# MEETING AGENDA

## Appearance Commission

Village of Homewood

A. **Public Meeting** for Case 24-34: Wind Creek Casino Site Signage and Sign Variance

**SHEET**  
**L-1.0**

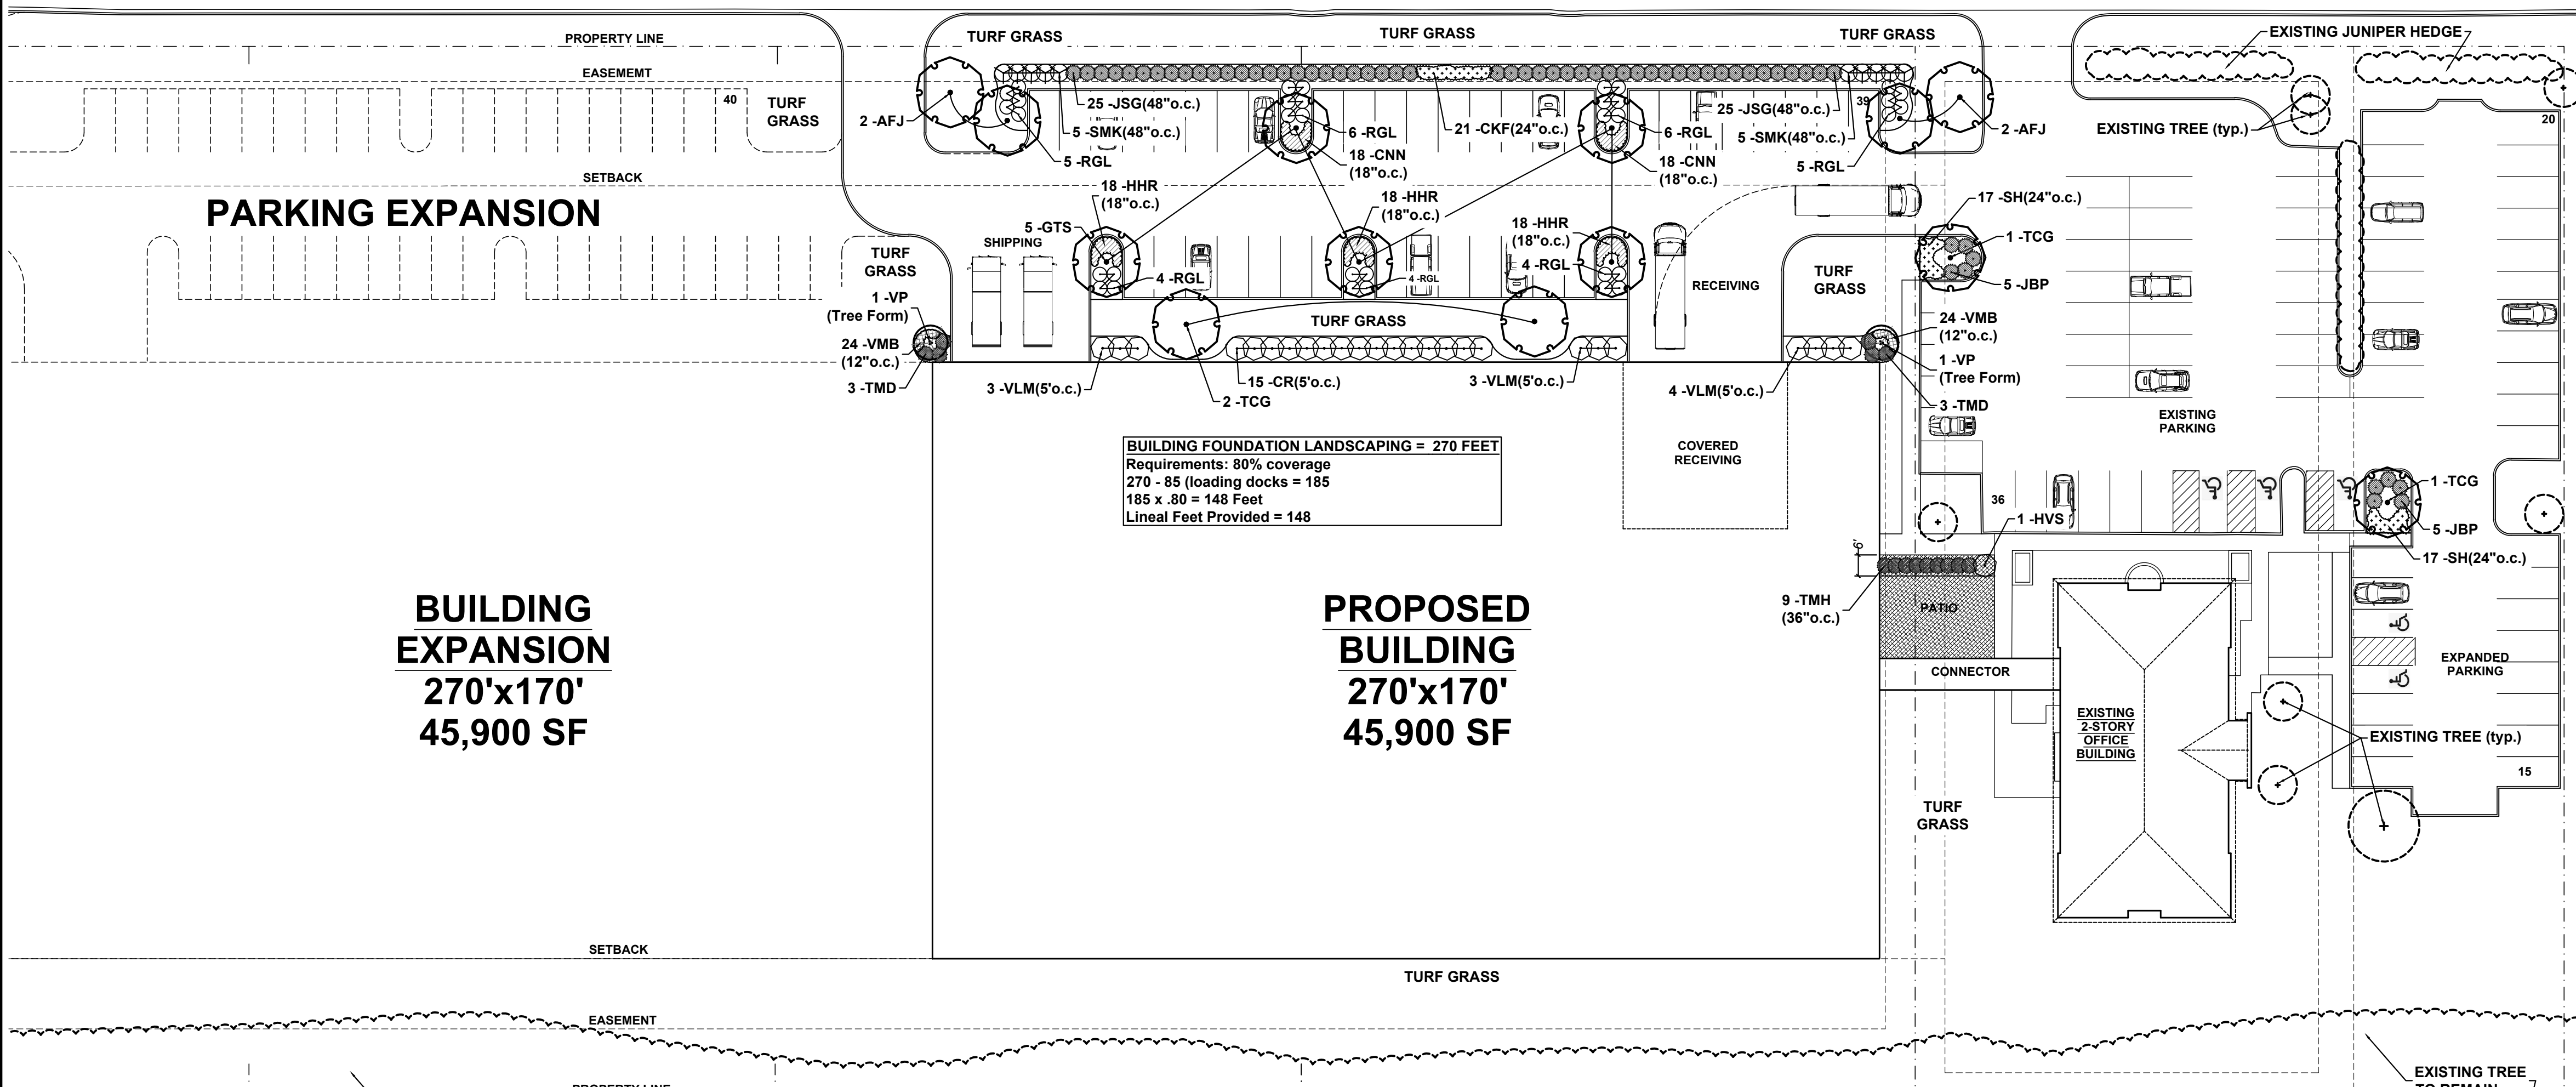
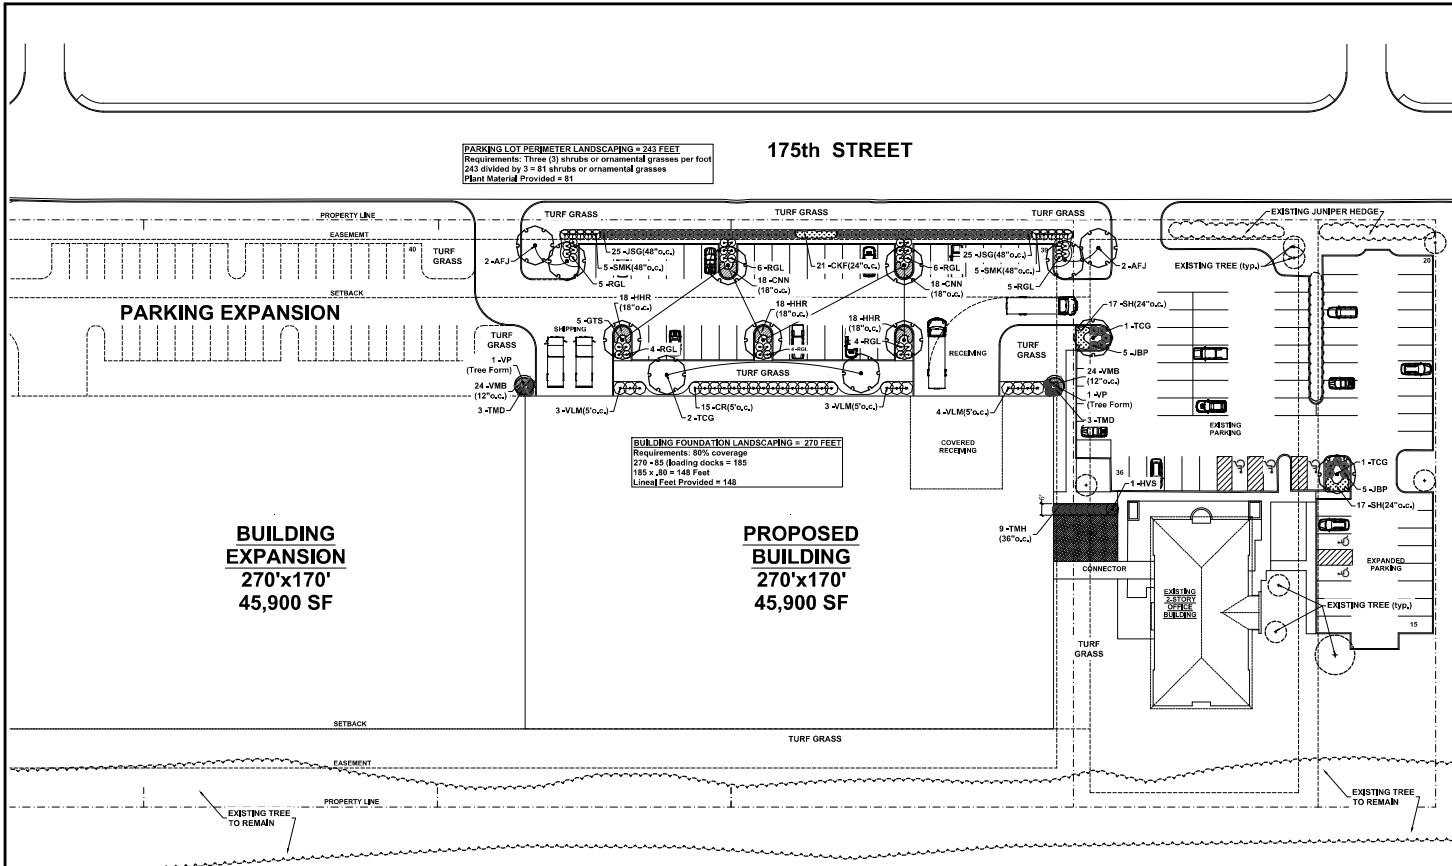
The Village Arborist has reviewed the landscape plans and provided the following comments:

- Grey dogwoods (*cornus racemosa*) are not recommended and should be replaced with diervilla, cameacyparis, or caryopteris trees.
- Juniper (*Juniperus*) and yew (*Taxus m. densiformus/Hicksii*) species are overplanted in the Village and should be replaced or drastically thinned out and varied with other shrubs. Swap for more native perennials.
- Substitute catamint (*calamantia*) for Russian sage.
- Replace all daylilies with coreopsis for yellow flowering plants.

Staff recommends the replacement of the plants following the Village Arborist's recommendations before the issuance of building permits. See *Recommended Appearance Commission Action*.

1. A revised landscape plan with the plant materials as proposed by the Village Arborist shall be submitted prior to the issuance of building permits.
2. All final color and material modifications on the office building at 1313 W 175<sup>th</sup> Street shall be applied to the structural elements of the monument signage on the site.
